Access Compliance Report

Public Rights-of-Way

(Curb Ramps)

Intersection ID: 10033082	Main Street: NORTH_REA_PARK_LN	Cross Street: N/A	Location:	N
ADA ID: 9AC5624311DD	Ramp Type: Perp	Initial Pass/Fail: Fail	Overall Compliance: No	Severity Score: 13.75
Codes/Mitigation Info/Possible Solution		Field Measurements/Component Compliance

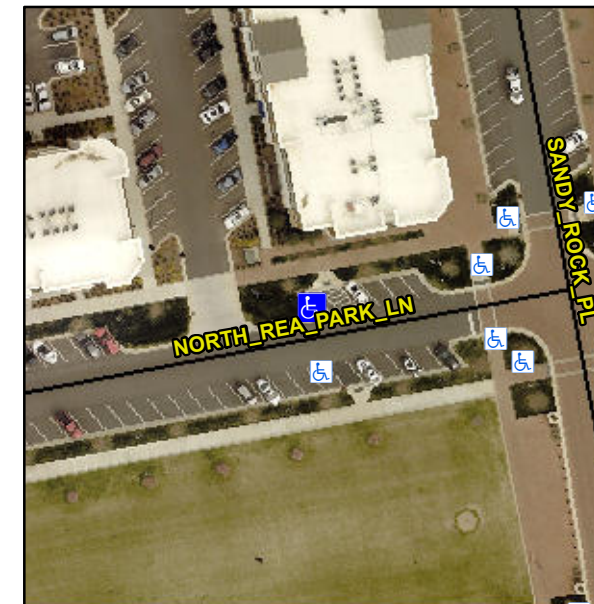
Not Found, R304.2.2, R304.5.3

Compliance	Description	Data	Compliance	Description	Data
N/A	Ramp Length (in)	91.0	No	Ramp Slope (%)	9.6
Yes	Ramp Width (in)	59.0	No	Ramp XSlope (%)	2.3
N/A	Flare Type LT	N/A	N/A	Flare Type RT	N/A
N/A	Flare Slope LT (%)	N/A	N/A	Flare Slope RT (%)	N/A
N/A	Flare Traversable LT?	N/A	N/A	Flare Traversable RT?	N/A
N/A	Landing Length (in)	N/A	N/A	DWS Provided?	N/A
N/A	Landing Width (in)	N/A	N/A	DWS Contrast?	N/A
N/A	Landing Slope (%)	N/A	N/A	DWS Length (in)	N/A
N/A	Landing X Slope (%)	N/A	N/A	DWS Full Width?	N/A
N/A	Landing Curb? (Y/N)	N/A	N/A	DWS Offset (in)	N/A
N/A	Shared Landing?	N/A			
N/A	Gutter Ponding?	N/A	N/A	Gutter Slope (%)	N/A
N/A	Gutter Lip Ht (in)	N/A	N/A	Gutter X Slope (%)	N/A
N/A	Painted X Walk1?	No	N/A	Painted X Walk2?	N/A
	X Walk 1 Direction	To S		X Walk 2 Direction	N/A
N/A	X Walk 1 Width (in)	N/A	N/A	X Walk 2 Width (in)	N/A
	X Walk 1 Slope (%)	2.4		X Walk 2 Slope (%)	N/A
	X Walk 1 X Slope (%)	0.4		X Walk 2 X Slope (%)	N/A

Remove & Replace Entire Ramp.
